**BREWSTER FIRE DEPARTMENT**  
Target Hazard Planning Group  
Brewster Fire Department  
501 North Main Street  
Brewster, NY 10509

Thank you for allowing the Brewster Fire Department the continued opportunity to review the plans for the “Brewster Yards” project. With regard to the installation of multiple gates on Fields Corners Rd. and the Carmel Town Line, we would like to offer the attached recommendations.

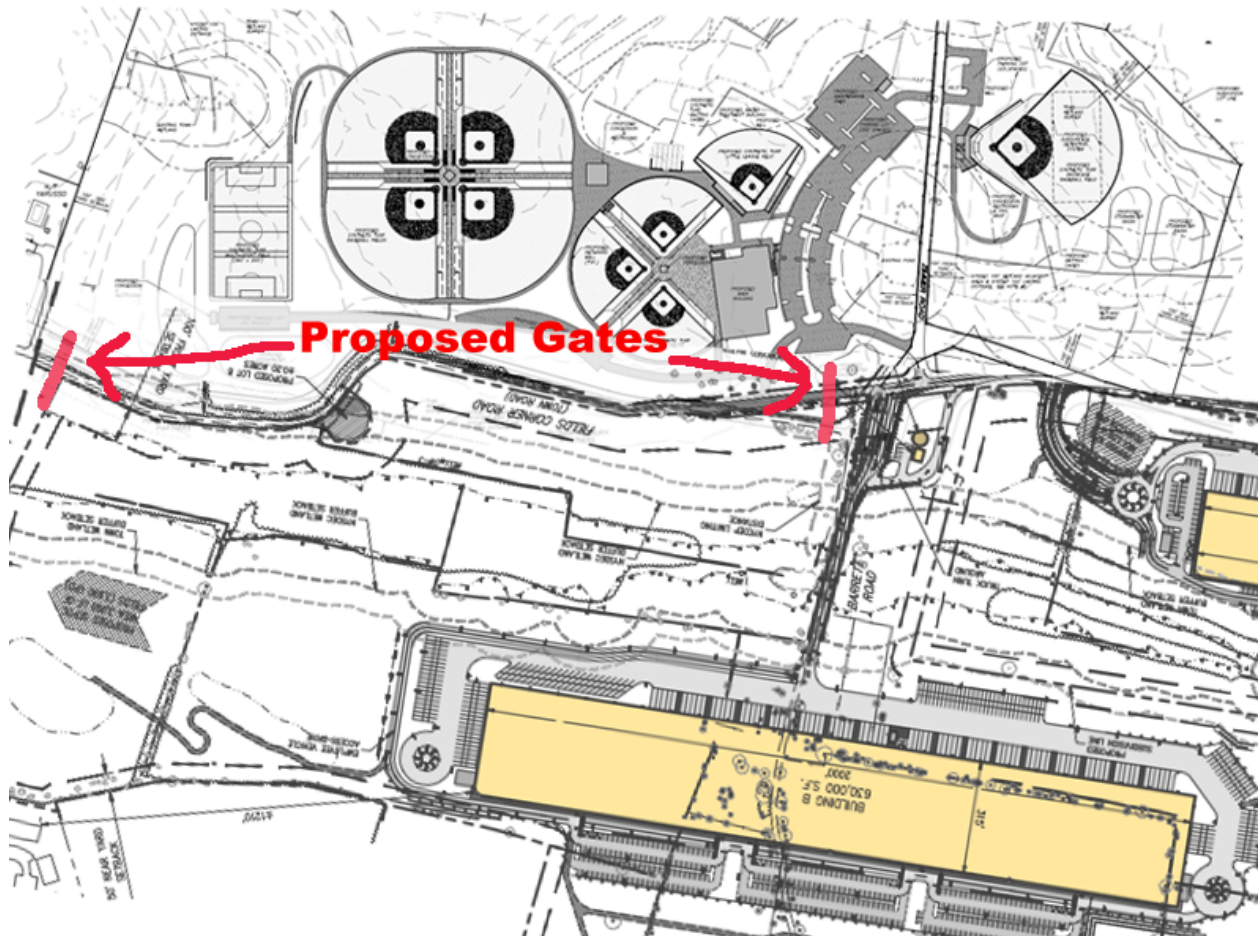
The placement of gates at the indicated areas could have a detrimental effect upon our ability to safely and efficiently respond to the site for an emergency.

1. Closing off Fields Corner Rd. would seal off emergency access to the majority and probably most used areas of the Brewster Yards project.
2. If two gates were to be installed, what would happen during winter months with snow on the ground?

3. Would the area between the gates be plowed?
4. Would the roadway between the gates be properly maintained? (potholes and freeze / thaw surface breaks?)

5. A gate at the Patterson Town line would also potentially slow mutual aid companies should we need them to respond to the Interstate Logistics ware house or Brewster Yards for a Fire / EMS mutual aid.

6. Gating access would force mutual aid companies to take a circuitous route to reach the assignment.
7. Perhaps Speed Humps would be a better option.

If a gate must be installed, then we would recommend that only one gate be installed at the Patterson Town Line. In addition, this gate should have the following specifications and abilities;

1. The gate should be a minimum of 9 feet wide to allow our vehicles to pass.
2. The gate should be equipped with a sensor that would automatically open when a specific siren tone is projected near the gate location. (This would probably be the most desired and least obstructive to the response process.)
3. If a lock must be installed, Keys must be provided to Carmel Fire Department, Patterson Fire Department and the Brewster Fire Department. We would recommend that the lock be the same as the Fire Road locks currently in use.
